TECHNICAL INFORMATION LETTER

TIL N° T-189-24-003

**SUBJECT: Frame STA 5700, MLG Slant Beam Attachment
Inspection**

Helicopters Affected: All AW149/AW189 helicopters

Forward section - Left/right frame at STA5700 - Detailed inspection

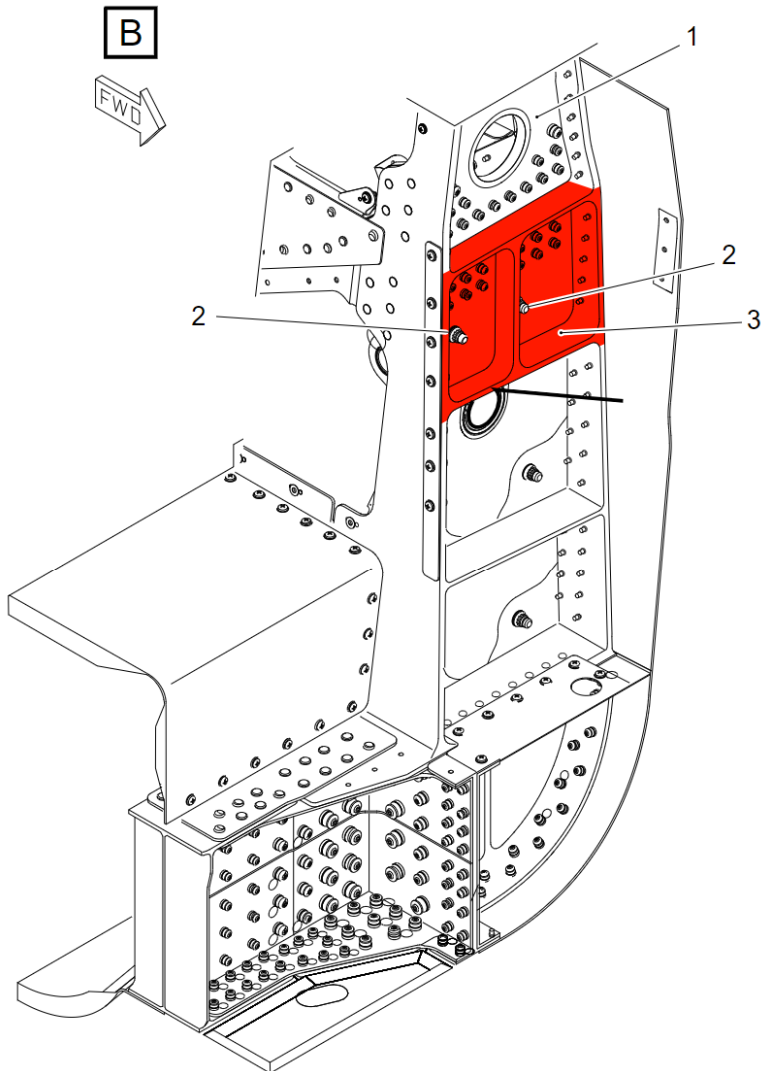
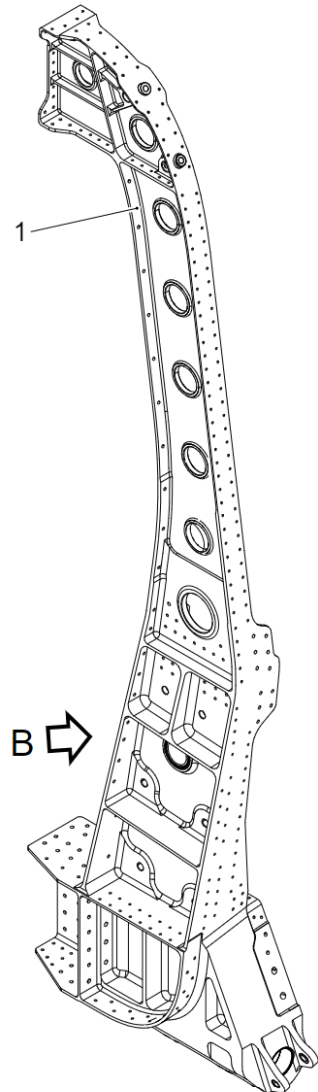
Following a recent review of Mandatory Inspection (MI) requirements for Main Cabin Assy, a dedicated inspection affecting the area highlighted in Annex A is required. This Inspection is applicable to those helicopters that have reached 14765 landings and needs to be repeated regularly after having reached this value.

- **EASB189-397** that is going to be released will provide the instructions to perform the detailed inspection for cracks of the areas (3) shown in Figure 1 of Annex A. No special tool is required.
- A new Mandatory Inspection will be included in the relevant Aircraft Maintenance Planning Information (AMPI) at the first favourable occasion.
